ITEM TITLE: PC 23 08 DR 02 – *Dollar General Design Review*

RESOLUTION PC 23 08 DR 02

A REQUEST FOR DESIGN REVIEW OF A 10,640 SQUARE FEET RETAIL STORE AND ASSOCIATED IMPROVEMENTS ON AN UNDEVELOPED ONE ACRE PARCEL AS SHOWN ON ASSESSOR'S MAP # 18-12-23-22, TL 06800 LOCATED AT THE NORTHEAST INTERSECTION OF HIGHWAY 101 AND 36TH ST.

A7

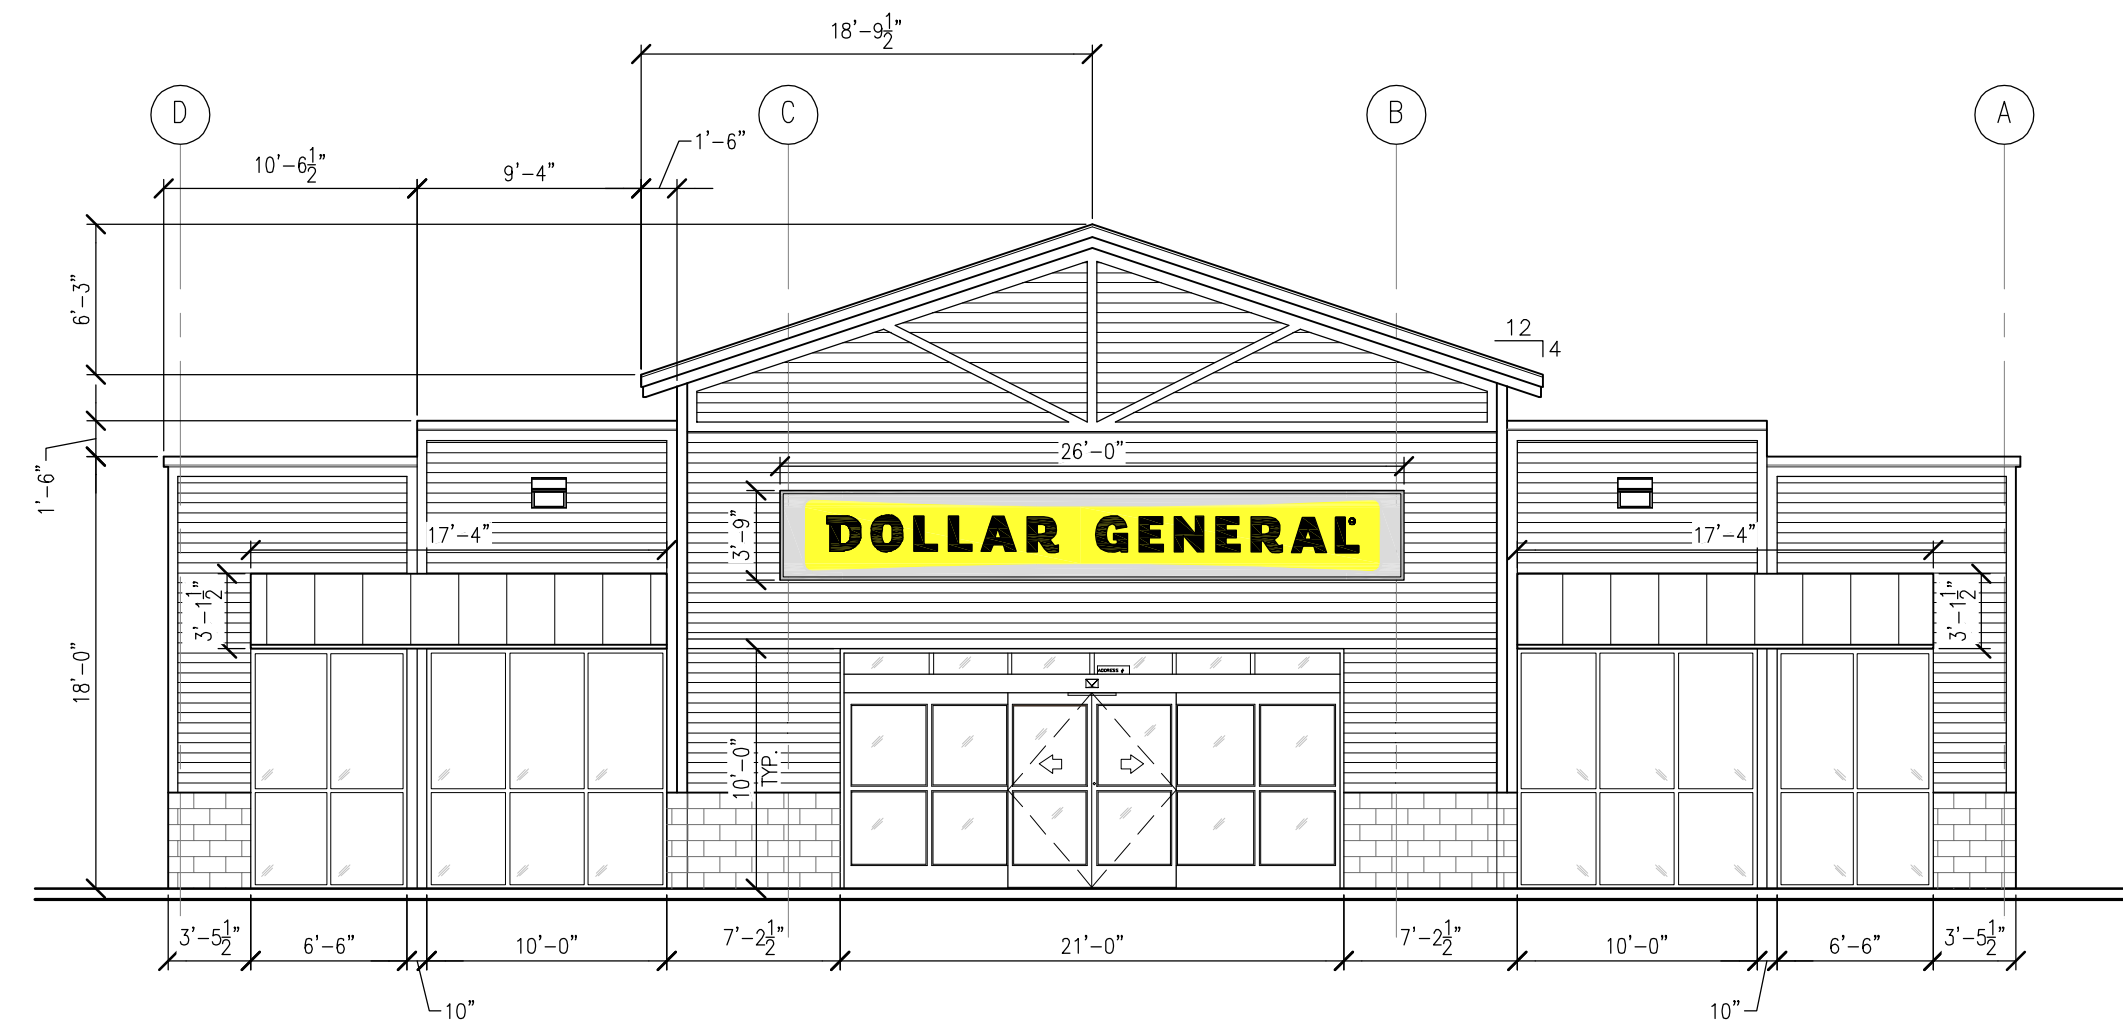
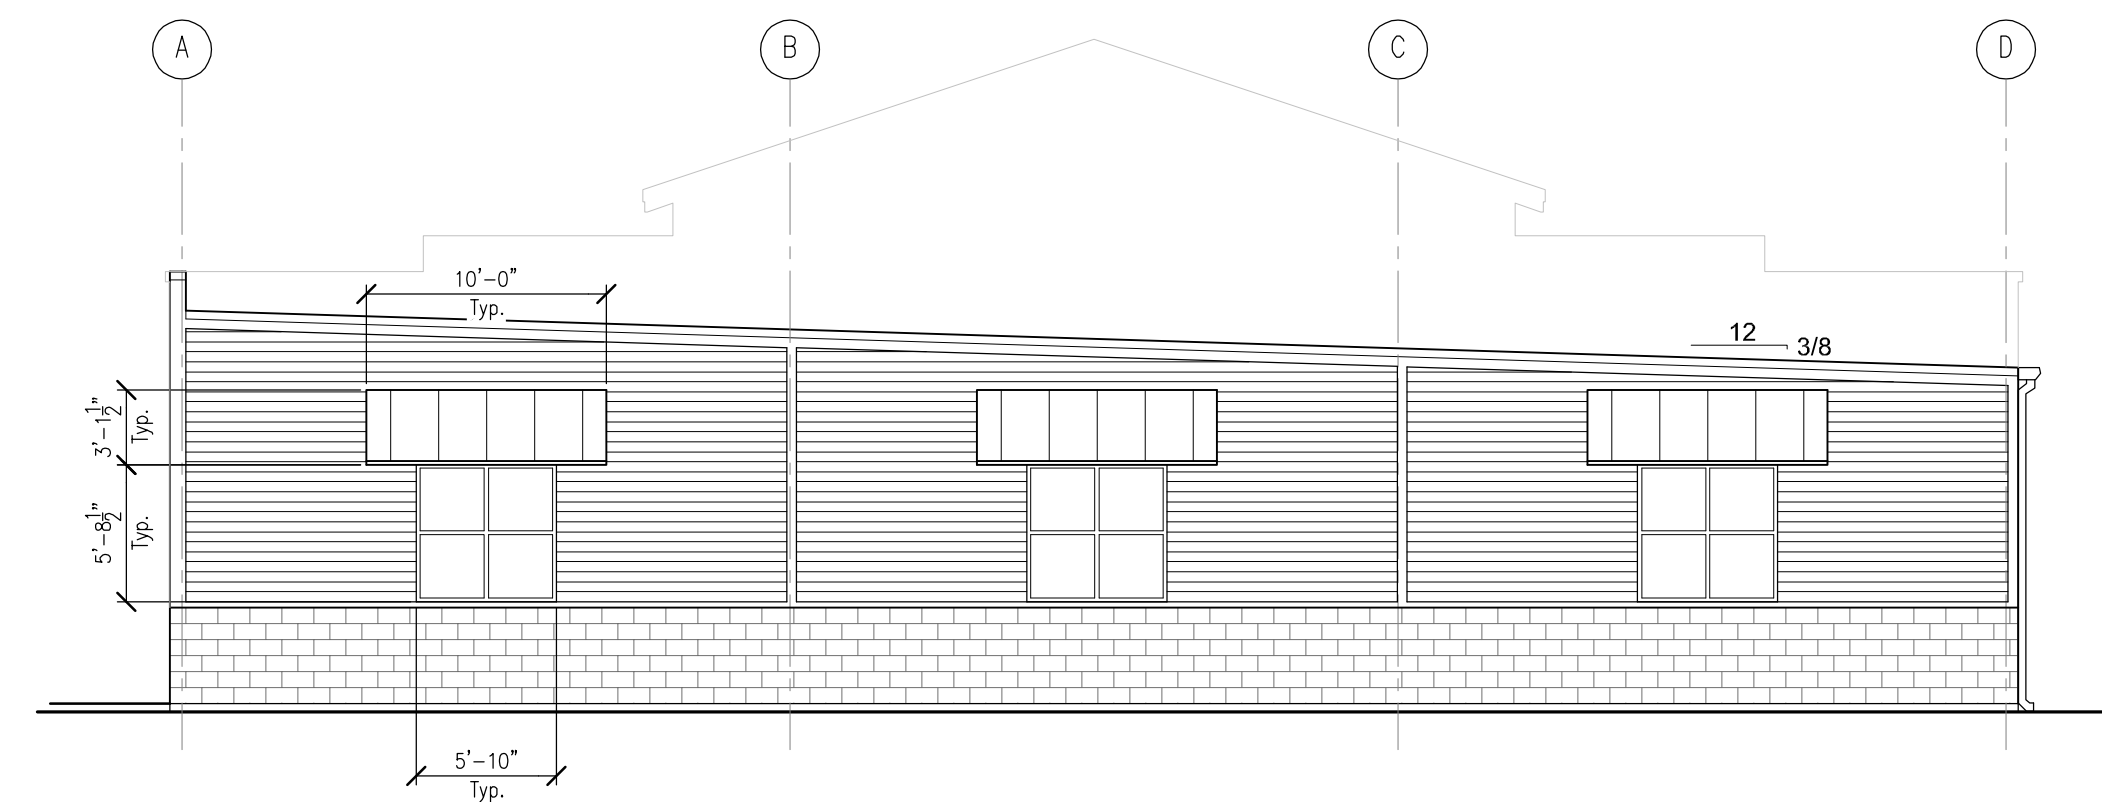
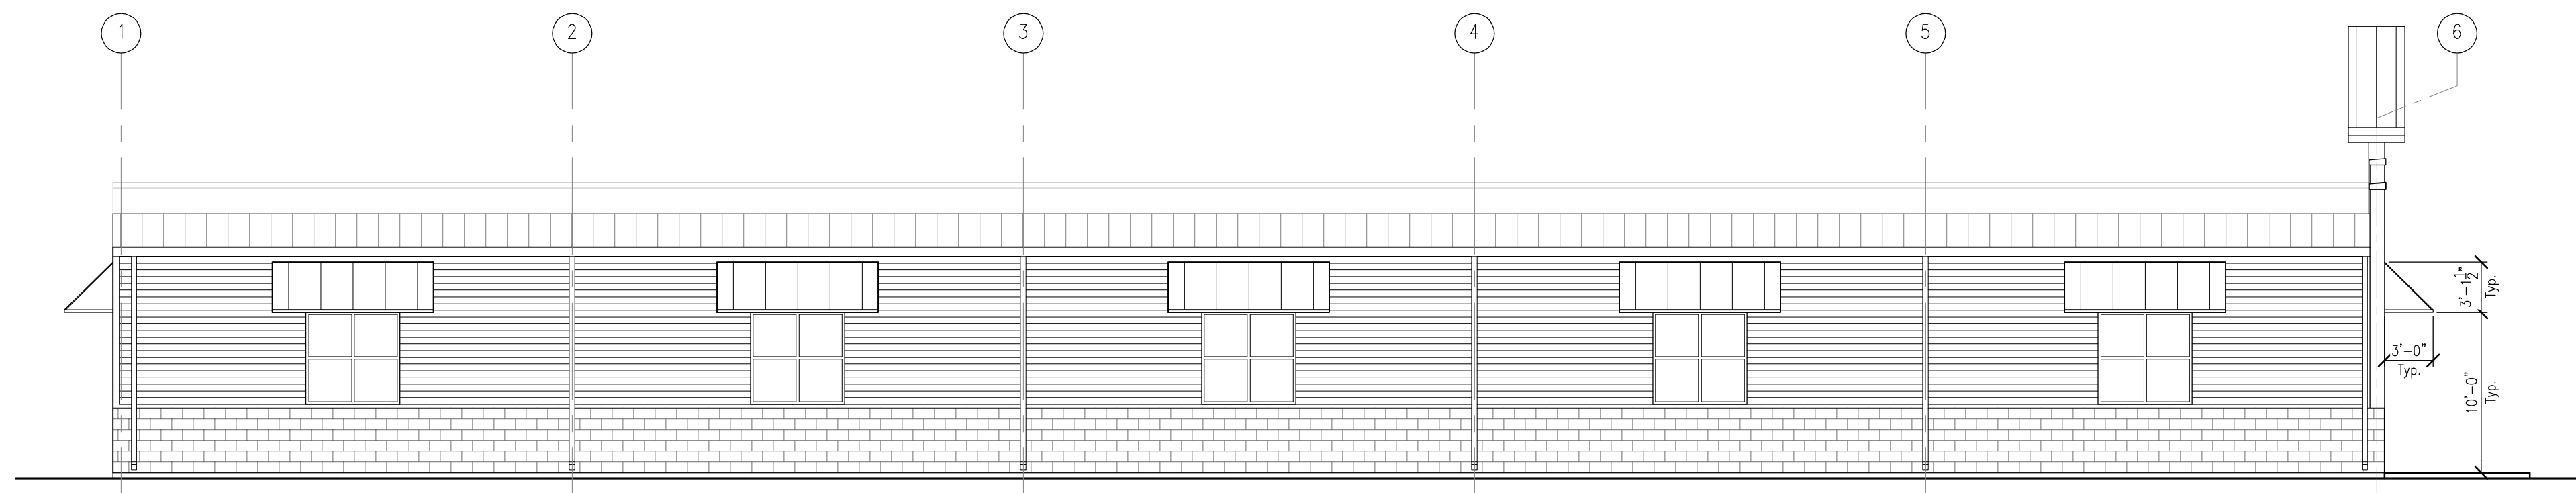
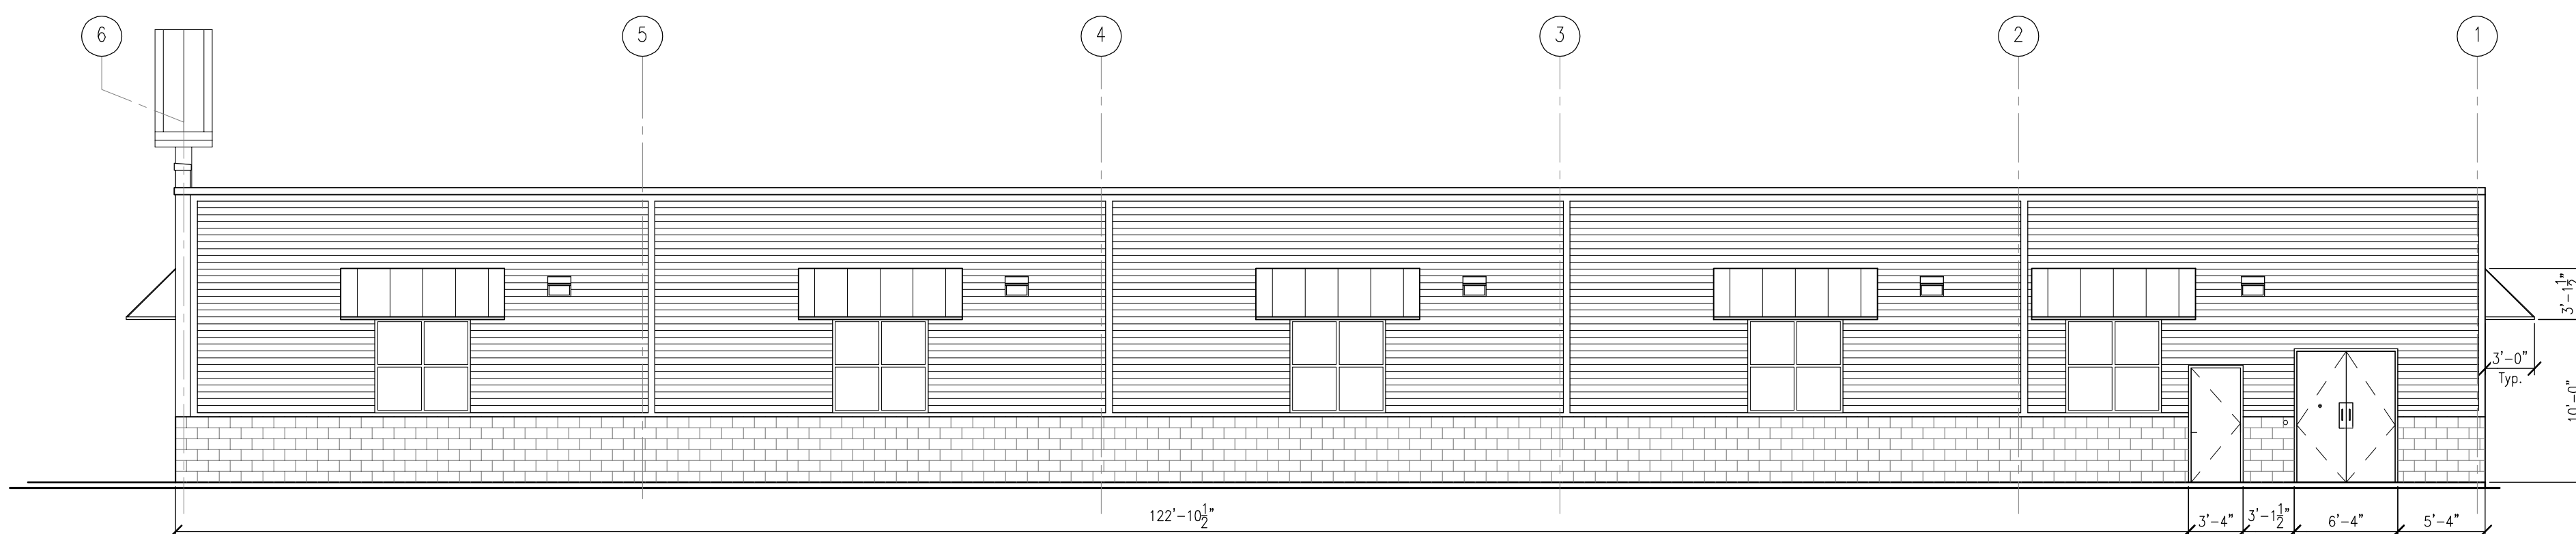
on the north elevation (Sheet A7). The exact color and composition of the trim, gutter and downspouts are unknown as this information has not been provided.

Spandrel glass windows (mostly faux) contain trim. The width and color are unknown and conditioned. The awnings provide a decorative feature atop these windows. Although not all elevations provide glazing percentages, the west side store front contains 33% of glazed surface area (Exhibit D, Sheet A7). Although visible from the highway, the north and south sides of the store will not directly face the highway. Criterion met as conditioned.

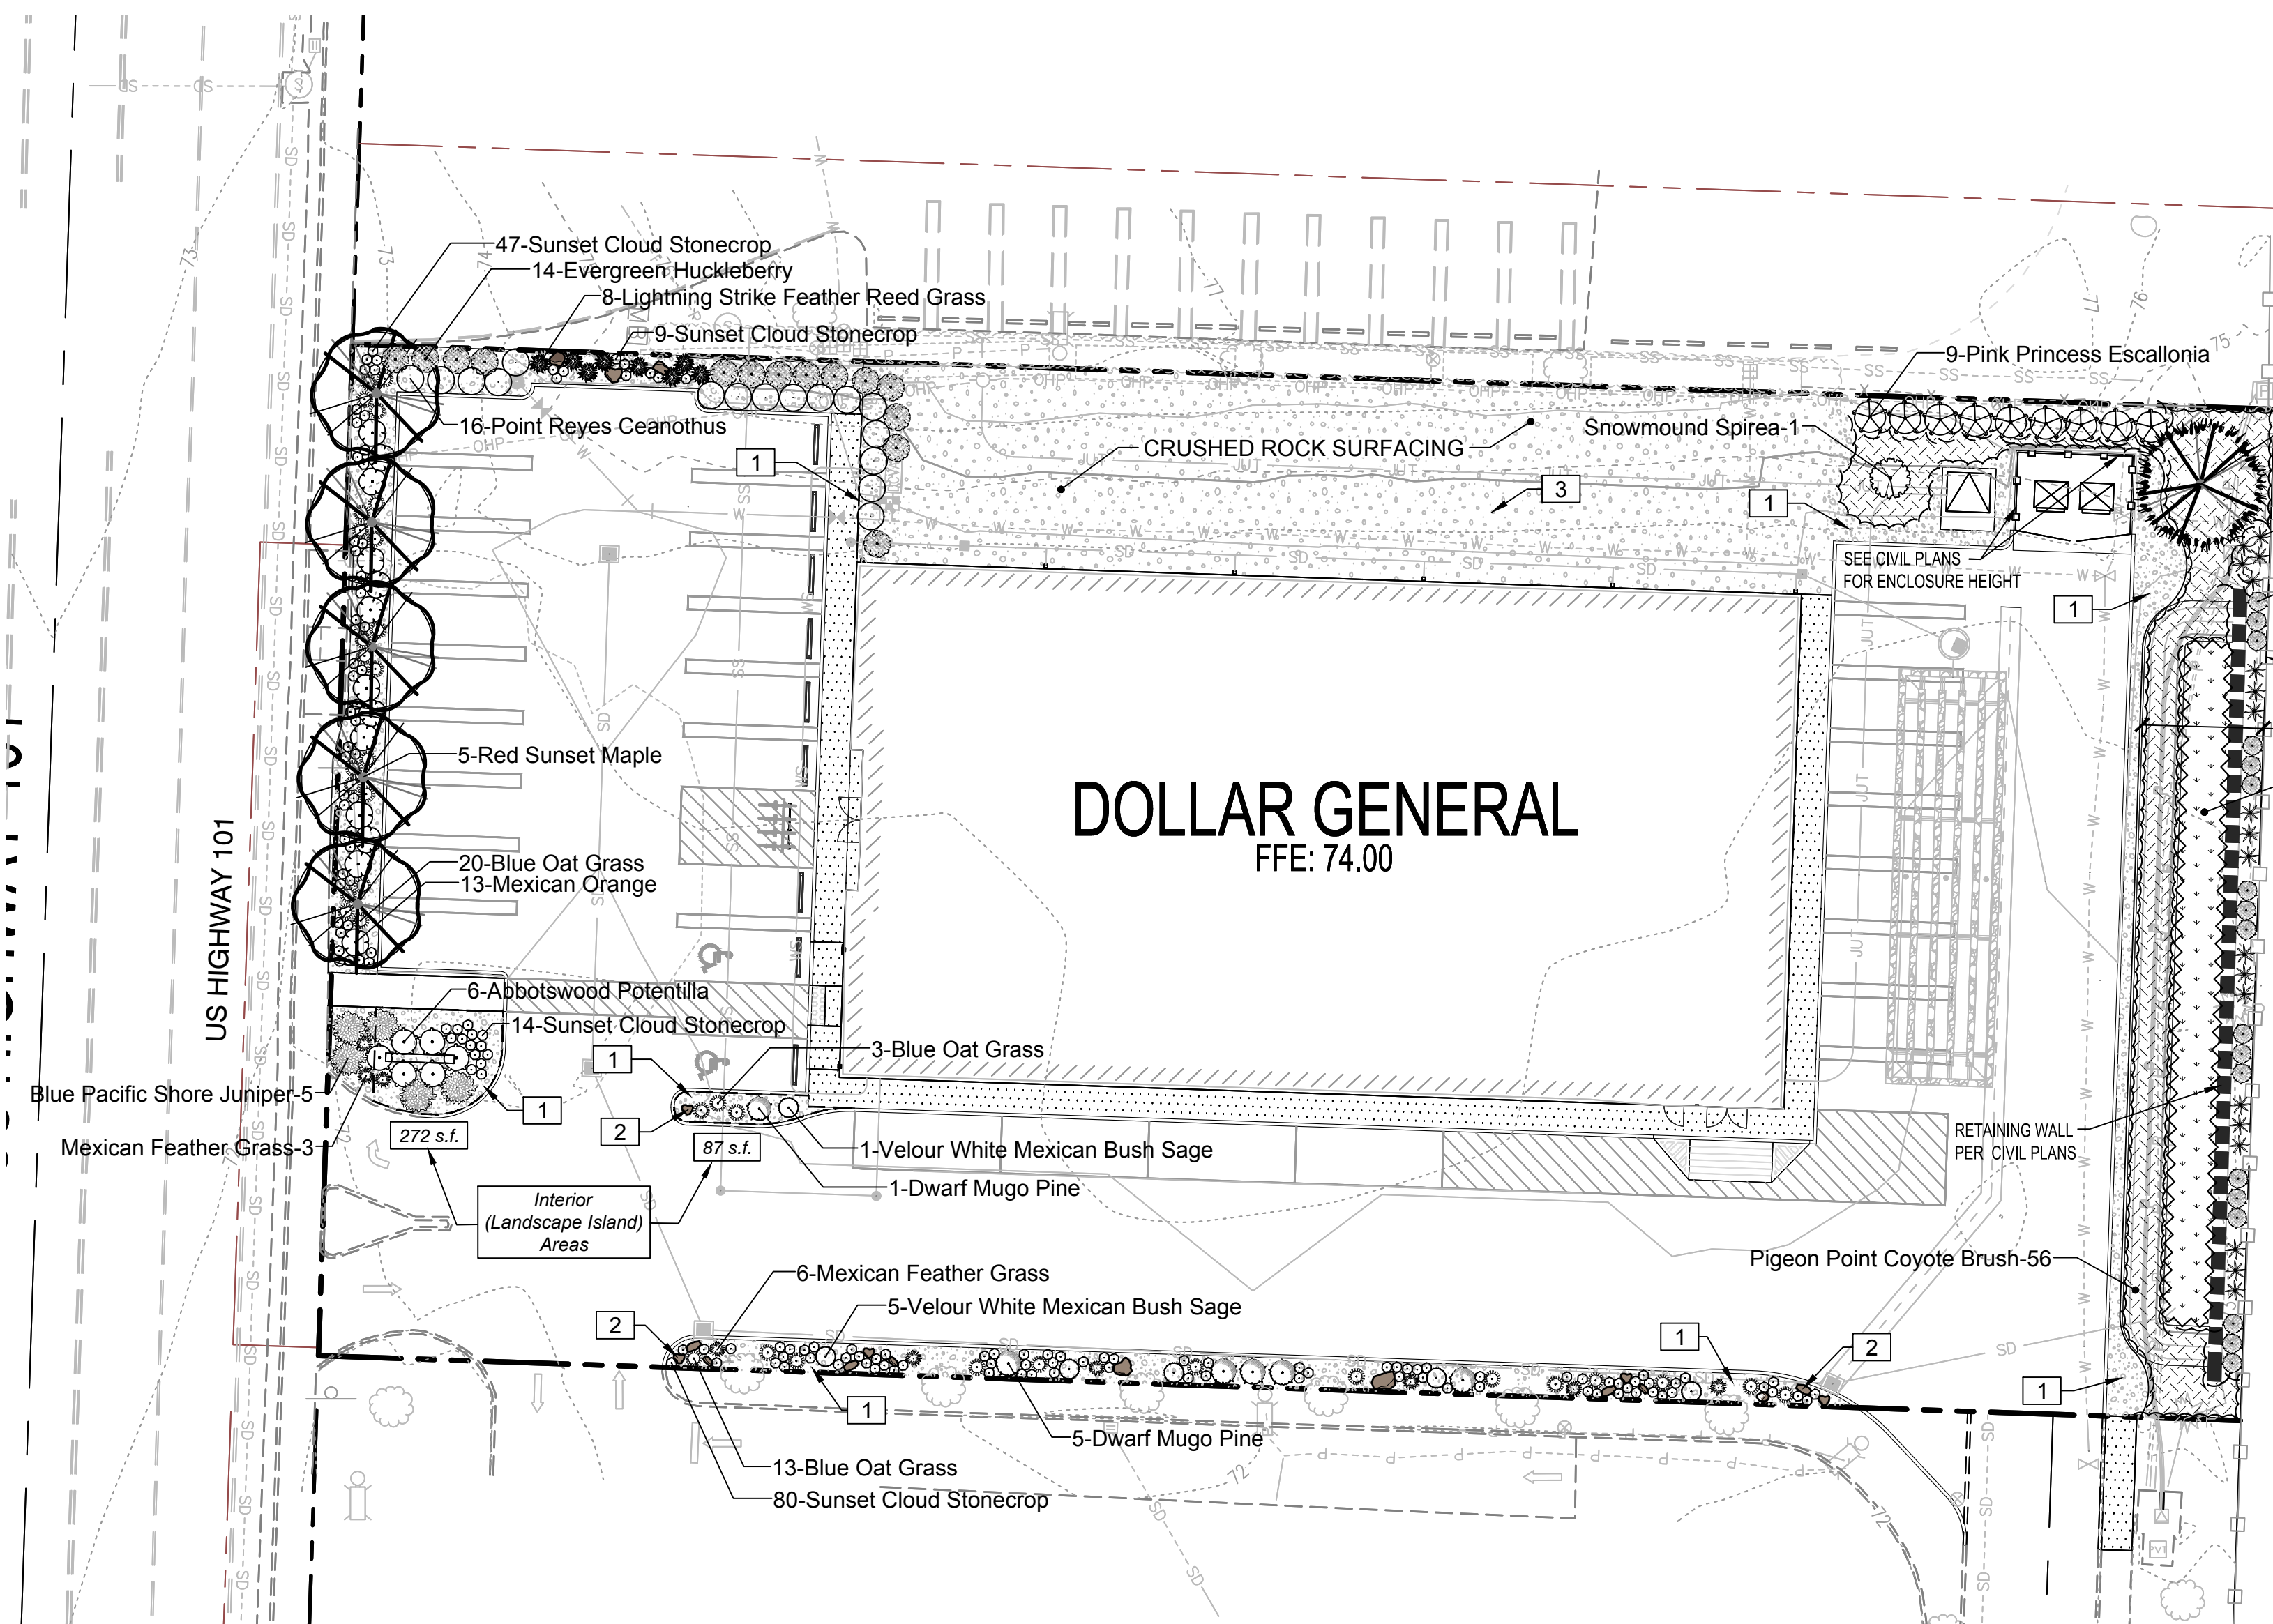
- 7-1. Per FCC 10-34-3-2 D, if any existing trees are to be preserved, these shall be delineated on a recent aerial photo or site plan drawn to scale.
- 7-2. Prior to the issuance of building permits, the Landscape Plan shall remove Landscape Specifications Note numbers 11, 12 and 14, or modify these to a change in plantings.

- 7-5. The two parking islands located north of the Highway 101 driveway approach do not contain trees. Per FCC 10-34-3-6 B, the applicant shall provide a minimum of one tree selected from the Tree and Plant List for the city of Florence installed per island.

- See revised landscaping plans.
 - **10-34-3-3:** Minimum landscaping area is 15%. Sheet LS-01 states minimum lot coverage at 15%, but incorrectly states this requirement at 4,323 sq. ft.
